# UNITED STATES PATENT AND TRADEMARK OFFICE

APPLICATION NO.	FILING DATE	FIRST NAMED INVENTOR	ATTORNEY DOCKET NO.	CONFIRMATION NO.
09/515,285	02/29/2000	Toshiya Fukuhisa	NAK1-BK00	2072

**Office Action Summary**

## DETAILED ACTION

FIG. 1

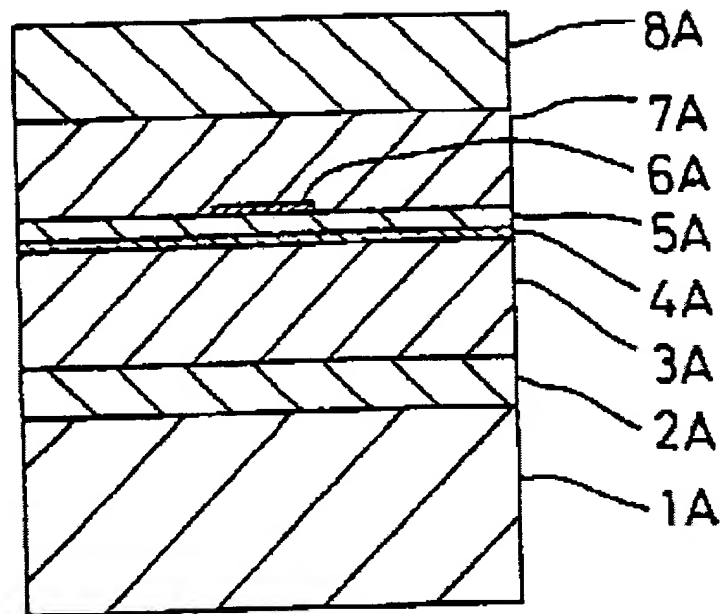
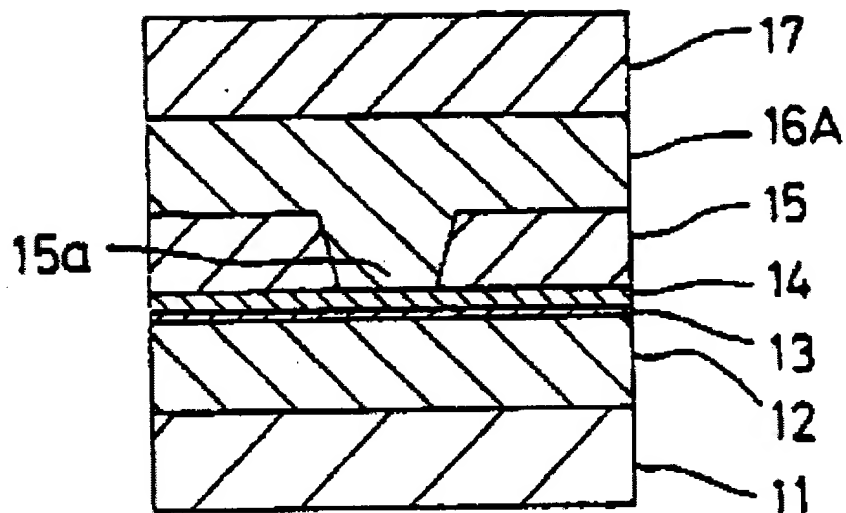
With respect to claim 1, Naito et al discloses a method for forming semiconductor laser device comprises n-type semiconductor substrate (1A), n-type cladding (3A), an active layer (4A), a p-type cladding (5A), a p-type buried cladding (7A), a current blocking (15), note cols. 1-16, see figs 1-9.

**FIG. 1**

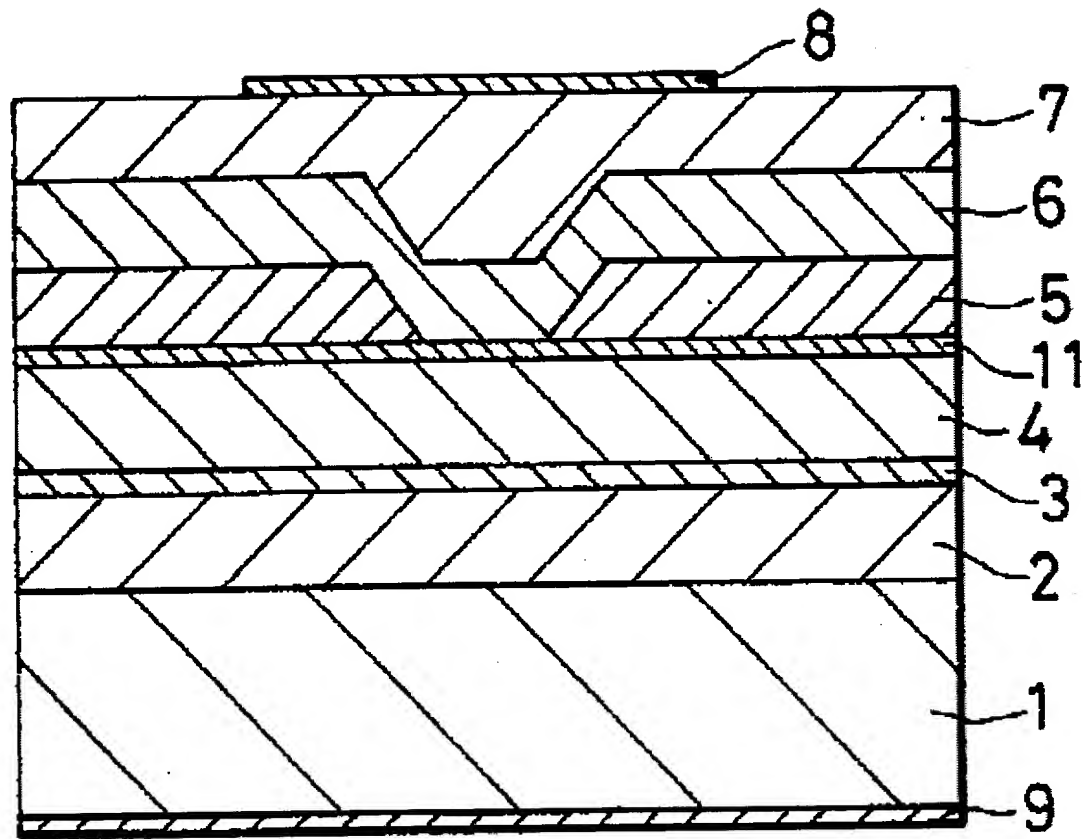
With respect to claim 11, Naito et al discussed all above except for the current blocking interface between p-type cladding and p-type buried cladding. Whereas Yoshizawa discussed about the current blocking interface between p-type cladding and p-type buried cladding, note col. 3, see fig 1. For the benefit of the current blocking interface between p-type cladding and p-type buried cladding, it would have been obvious to one having ordinary skill in the art at the time the invention was made to provide Naito with the current blocking interface between p-type cladding and p-type buried cladding as taught or suggested by Yoshizawa.

With respect to claim 12, Naito et al discussed all above except for the interjacent layer being positioned between the current blocking and p-type cladding. Whereas Yoshizawa discussed about the interjacent layer (11) being positioned between the current blocking (5) and p-type cladding (4), note col. 3 , see fig. 1. For the benefit the interjacent layer being positioned between the current blocking and p-type cladding, it would have been obvious to one having ordinary skill in the art at the time the invention was made to provide Naito with the interjacent layer being positioned between the current blocking and p-type cladding as taught or suggested by Yoshizawa.
